Subject: Turkey Point Units 3 and 4  
Docket No. 50-250 and 50-251  
Response to Request for Additional Information (RAI)  
Regarding Third 10-year Inservice Inspection Interval Relief Requests 1A, 14A, 15A

RESPONSE TO REQUEST FOR ADDITIONAL INFORMATION  
TURKEY POINT UNITS 3 AND 4  
RELIEF REQUEST NOS. 1A, 14A, AND 15A  
DOCKET NOS. 50-250 AND 50-251

**TURKEY POINT UNITS 3 AND 4  
THIRD 10-YEAR INSERVICE INSPECTION INTERVAL  
RELIEF REQUEST NUMBER 1A (Revised) Rev 1**

RPV Lower Head Ring-to-Bottom Head Weld (3-WR-9 and 4-WR-9)  
Figure 1

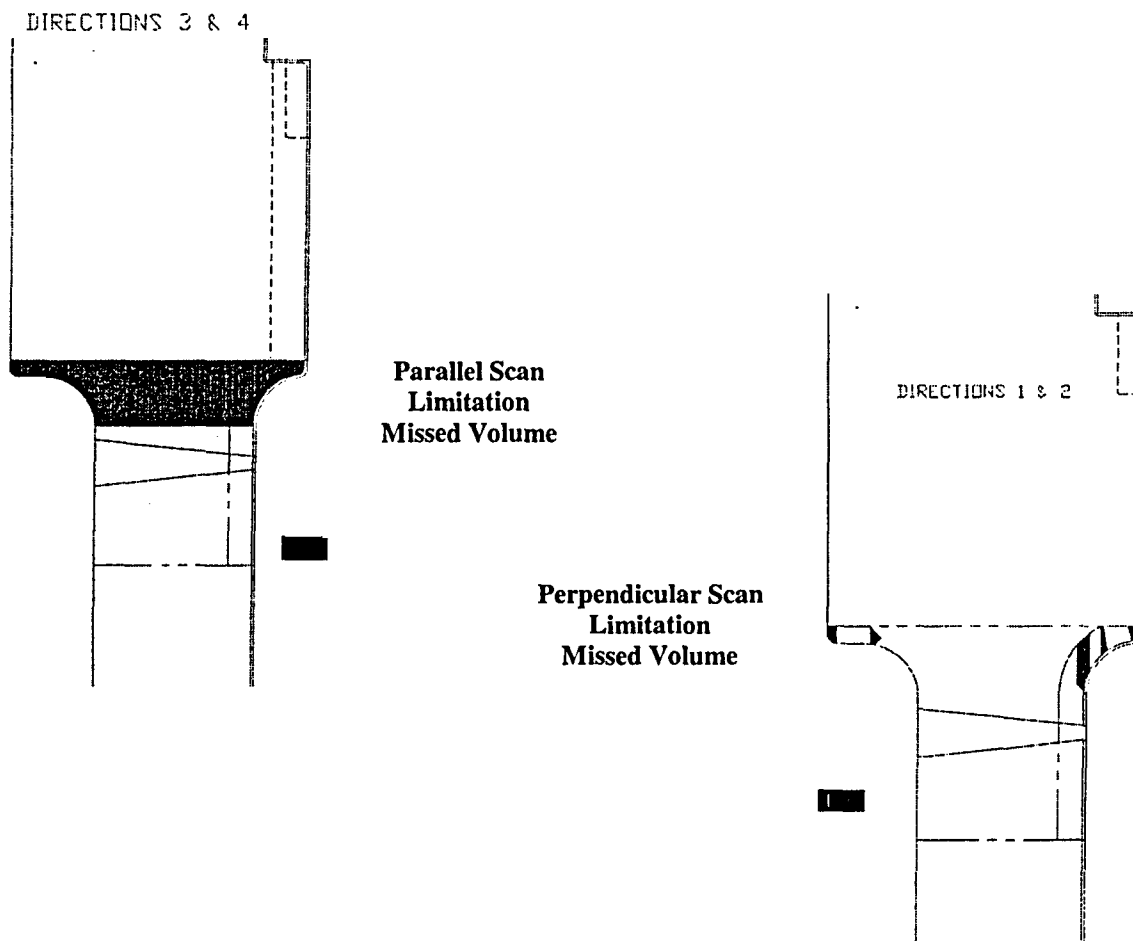
2. In Florida Power and Light Company (FPL) letter dated February 20, 2006, it is stated the objective of Relief Request 1A is to resubmit the previously approved Relief Request No.1. The request also states that this revision submits the examination volume coverage obtained during the third 10-year ISI interval inspection. In comparing Relief Request 1 with Relief Request 1A, the upper shell-to-flange weld is included in both requests. Welds 3-DO-A, 3-DO-B, 3-DO-C, 4-DO-A, 4-DO-B, 4-DO-C are included in Relief Request 1, but they are not included in relief request 1A. Relief Request 1A contains additional examinations that had limited coverage, welds 3-WR-9 and 4-WR-9 and the 1-inch annular surface of flange surrounding each reactor vessel stud hole.

**Does Relief Request 1A supersede Relief Request 1, or is it in addition to Relief Request 1? If Relief Request 1A is to supersede Relief Request 1, was essentially full coverage obtained on welds 3-DO-A, 3-DO-B, 3-DO-C, 4-DO-A, 4-DO-B, 4-DO-C? If relief request 1A is to be in addition to relief request 1, is the request for relief with regard to welds 3-WR-18 and 4-WR-18 any different than the request for relief made under Relief Request 1 (other than 71 percent coverage was obtained vs. 68 percent projected)?**

Relief Request 1A supersedes Relief Request 1. Greater than 90 percent coverage was obtained for welds 3-DO-A, 3-DO-B, 3-DO-C, 4-DO-A, 4-DO-B, 4-DO-C outlet nozzles for Unit 3 and Unit 4.

The request for relief for the WR-18 weld in Relief Request 1A is the same as in Relief Request 1.

Figure 4

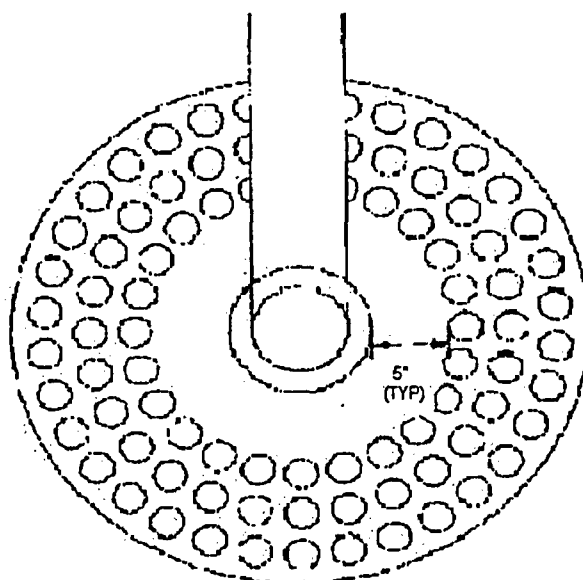
5. **In Relief Request 14, component 3-SRGN-01-IR is listed under examination category B-D, Item No. B3.120, which is applicable to the Pressurizer. In Relief Request 14A, component 3-SRGN-01-IR is listed as applicable to examination category B-D, Item No. B3.140. Please explain this change in classification of component 3-SRGN-01-IR.**

This is a typographical error. The examination category is B-D, Item No. B3.120.
